CONNECTICUT COASTAL MANAGEMENT MANUAL

SECTION 4

SITE PLAN EXAMPLES

SINGLE-FAMILY RECONSTRUCTION

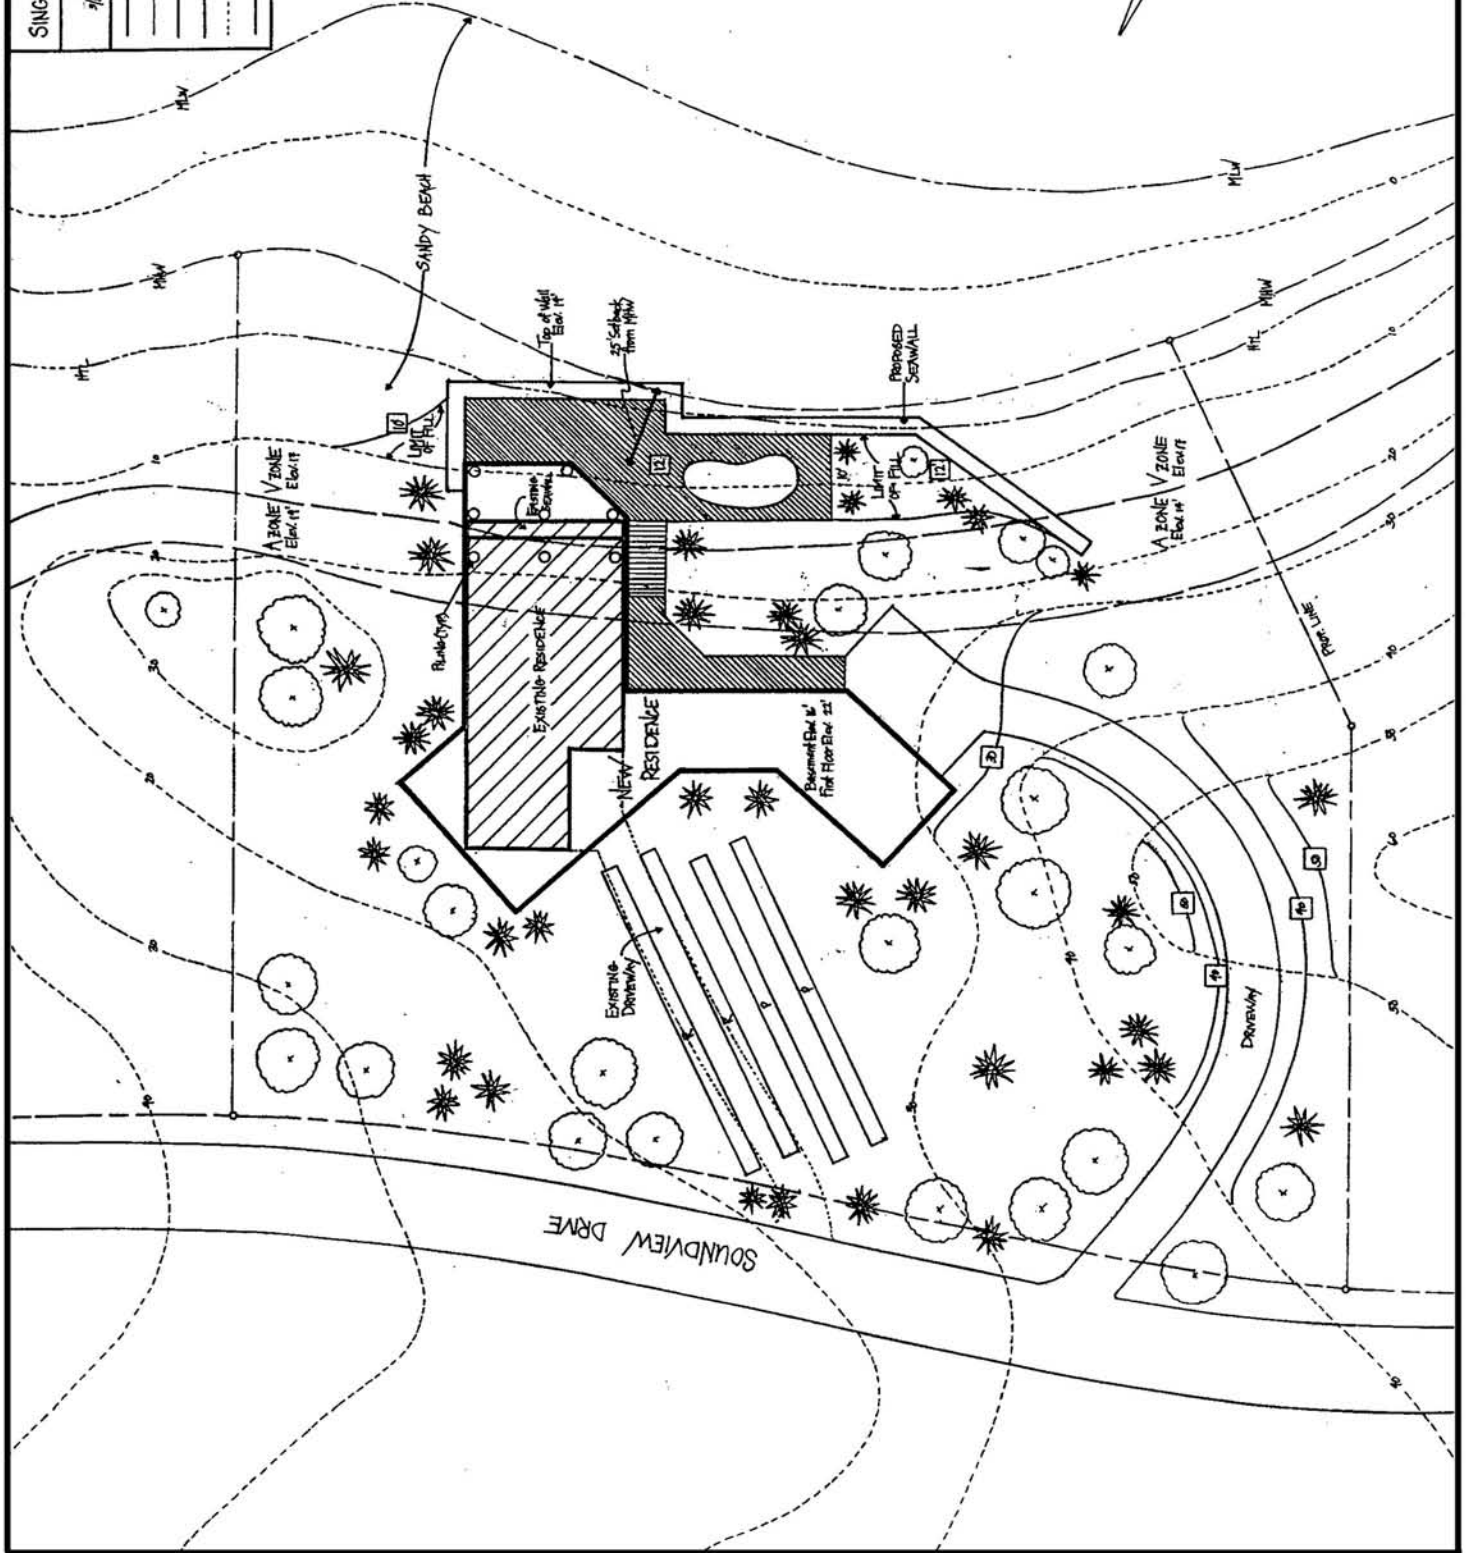
- 1) Tidal datums (i.e., mean high water and high tide line) and vertical datum (NGVD 1929) not shown.
- 2) Extent of beach resource not fully depicted.
- 3) No S&E controls.
- 4) Drainage not shown.

- 1) Proposal of shoreline flood and erosion control structure requires mandatory referral to OLISP in accordance with section 109d of the CCMA.
- 2) Seawall may be located on the beach.
- 3) Proposed dwelling in the V-Zone
- 4) Potential adverse impacts to coastal water quality - no stormwater best management practices (BMPs) proposed.
- 5) State coastal permits required for fill/stormwater discharge structures in tidal wetlands or areas below the high tide line.

The site contains significant topographic relief. With only 10' contours shown, it is difficult to determine specifically where the steep slopes on the property are. The proposal meets the town's building setback regulation and, since the portion of the dwelling located in the V-Zone is pile supported, it meets FEMA construction standards. However, the proposal is inconsistent with CCMA policies. First, proposed residential development in the V-Zone, even if it can be constructed to meet FEMA standards, should be located outside the V-Zone where possible to minimize hazards to life and property. In this case, the entire structure could not only be located outside the V-Zone, but landward of the A-Zone as well. Keep in mind that the flood zone boundary lines are not exact and given the scale (1" = 500') of the Flood Insurance Rate Maps (FIRMs), it is prudent to err on the side of caution (i.e. locate structures as far landward as possible). Additionally, the boundary lines on the FIRM maps are not drawn for specific properties, but for longer stretches along the coast. Thus, there are inherent inaccuracies built into the maps when they are applied to a particular parcel.

The proposal is also inconsistent with the CCMA's policy regarding shoreline flood and erosion control structures. Structural solutions are not allowed in this case since the house could be relocated such that no shoreline protection would be required during the expected useful life of the house. For more detailed information, please see the fact sheet for *Shoreline Flood and Erosion Control Structures*.

From a coastal permitting perspective, an application to construct the seawall as proposed including fill waterward of the high tide line could not be approved.

- In this example, the modifications required to render the site plan consistent with CCMA policies would drastically change the site plan. So much so that there would be no alternative but to deny the application without prejudice.
- The board/commission should clearly document the inconsistencies in its written finding.

- In making a subsequent proposal, the applicant should be informed that the residence should be located outside of the flood hazard area. In this case, that could be landward of elevation 14', even though the transposed A-Zone boundary crosses the 20' contour. Additionally, the applicant should be made aware that no shoreline flood and erosion control structures could be permitted now or in the future to protect the dwelling. Thus, the need to relocate the house as stated becomes evident.
- Due to the significant topographic relief on the property, appropriate and specific S&E controls should be shown on the plans.
- Stormwater BMPs should be shown on the plans. Potential solutions could include the use of depression storage, infiltration swales, vegetated buffers, and overland flow (runon). Structural measures such as catch basins and drywells should be avoided if possible.

MULTI-FAMILY DEVELOPMENT

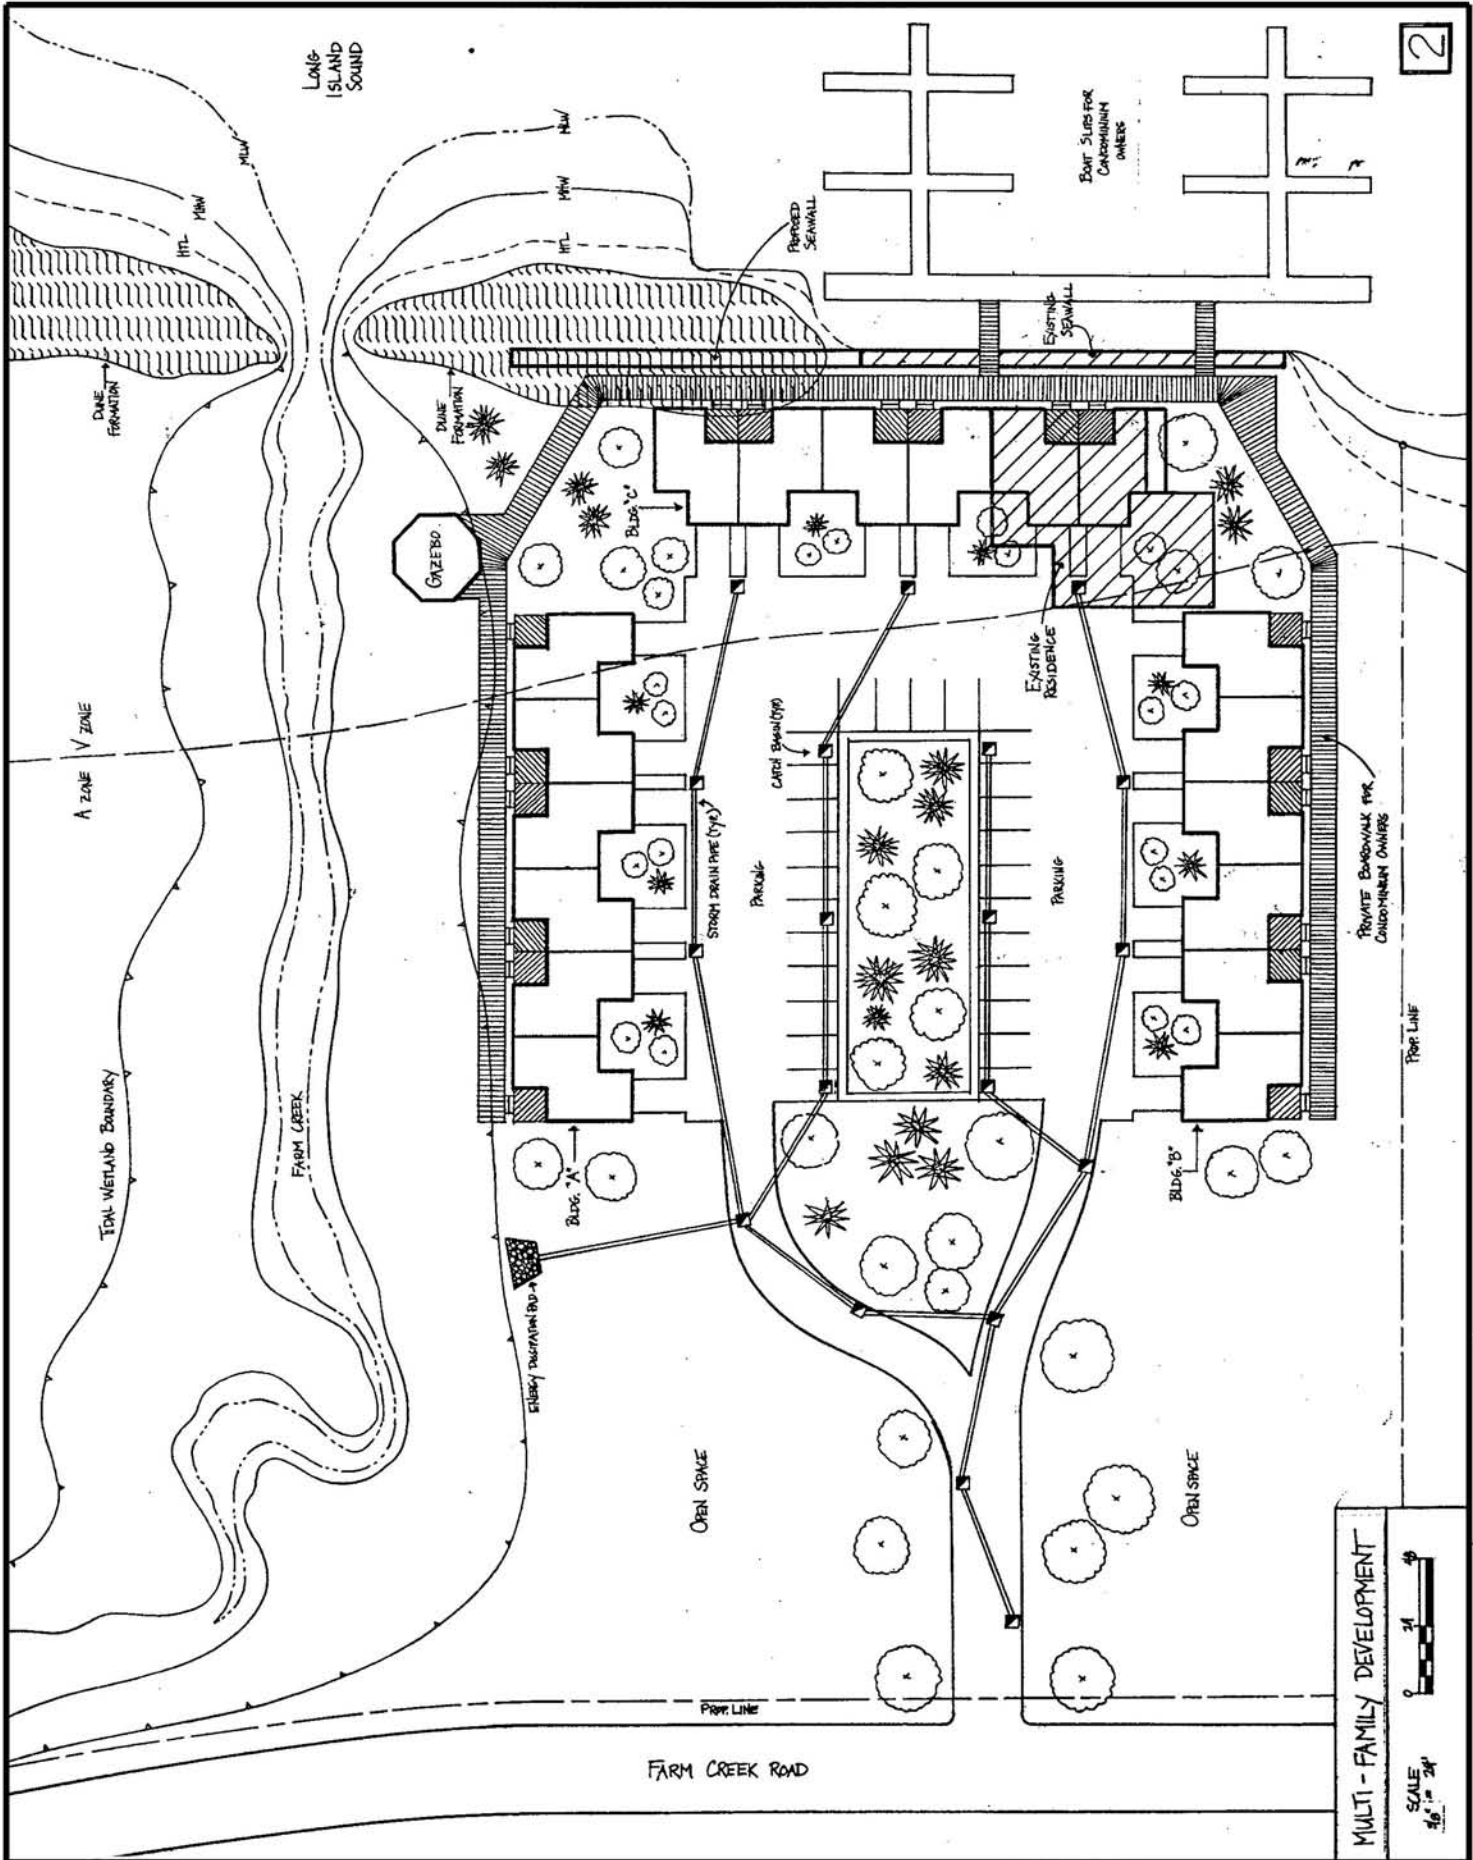
- 1) No vertical datum shown (plans should reference NGVD of 1929). This is particularly important in evaluating the accuracy of tidal datums (e.g., mean high water).
- 2) Accuracy of high tide line (HTL) is questionable. HTL is shown on plan at the same elevation as the tidal wetland boundary. Typically, the HTL is upland of the tidal wetland boundary.
- 3) Flood hazard area elevations are not shown.
- 4) The upland extent of the A zone not indicated on the plan.
- 5) Incomplete labeling of coastal resources at or adjacent to the site (e.g., intertidal flats?).

- 1) No water-dependent use of a waterfront site proposed (boat slips are accessory to a non-water-dependent use/boardwalk not available for public use).
- 2) Intense residential development in flood hazard V-zone
- 3) Flood and erosion control structure (i.e., seawall) extends onto dune/beach (such structures require mandatory referral to OLISP) would replace existing dune which provides a non-structural flood and erosion control and potential plant and wildlife habitat.
- 4) Protection of tidal wetlands and beach/dune system
- 5) Structural stormwater management system proposed which does not include any stormwater quality renovation measures. Includes direct discharge of stormwater to tidal wetlands without prior treatment.
- 6) Structures (walkway/gazebo) proposed in tidal wetlands require permit from OLISP.

There are no water-dependent uses proposed for this waterfront site. Developable waterfront property, particularly property that can support an active water-dependent use, such as a boat basin, is extremely rare and valuable in Connecticut. Many former water-dependent uses such as marinas, boat yards, and boat building operations have been replaced with office, residential, and other uses that need not be located along the water's edge. Because the proposed private boat slips and private boardwalk demonstrate that the site is capable of supporting water-dependent uses, the coastal site plan must be modified to incorporate some type of water-dependent use in order to ensure that future water-dependent use opportunities at the site are not lost. In this case, the zoning district may allow for residential use. If there is no requirement under the existing zoning to require an active water-dependent use (e.g., marina), the commission should require that general public access, commensurate with the size of the site, be incorporated into the site design.

While offering waterfront residential dwellings as close to the water as possible is an attractive prospect to developers, such a design often creates a myriad of coastal resource management concerns including: (1) proposals for future filling of coastal waters to construct flood and erosion control structures (e.g., seawalls) to protect new construction; (2) increased likelihood of future unpermitted or illegal filling of coastal waters/tidal wetlands; (3) loss of coastal public access; (4) estuarine habitat encroachment/disturbance; (5) increased flood hazards; and (6) loss of riparian buffers.

- The proposed development must be significantly modified to address the above-reference coastal management concerns, as described below:
- The proposed extension of the seawall into the dune should be eliminated. If the applicant is concerned about future flood and erosion in this area of the site, the dune could be modified/expanded with snow fencing and native beach grass plantings to enhance the dune's flood and erosion control properties.

- The residential units and boardwalk should be relocated towards the road out of the V-zone and dune. Such a redesign would decrease future potential hazards to life and property from flooding and erosion, relocate the open space adjacent to the water for use by the general public to access coastal waters and preserve riparian habitat. Coastal public access areas should always be carefully designed and include appropriate amenities to provide attractive and usable public facilities. It's also important to ensure that coastal public access is ensured through a duly executed and legally binding access easement.

- Stormwater should be retained and treated on-site to the maximum extent practicable using appropriate best management practices. The open space areas and parking lot islands could potentially be used as areas for retention basins or swales. Retention of the first inch of runoff onsite, if feasible, would reduce discharges of fresh water to tidal wetlands and minimize pollutant loadings to tidal wetlands and coastal waters.

- Proposed structures should be set back from both the tidal wetlands and the dune formations. Buffers between these resources will allow them to grow/migrate, protect them from potential adverse impacts of human activities, and reduce impacts to the wildlife that depend upon these resources for one or more parts of their life cycle.

Because of the extent of modifications necessary to render this proposed residential development consistent with the goals and policies of the Connecticut Coastal Management Act, the proposal should be denied.
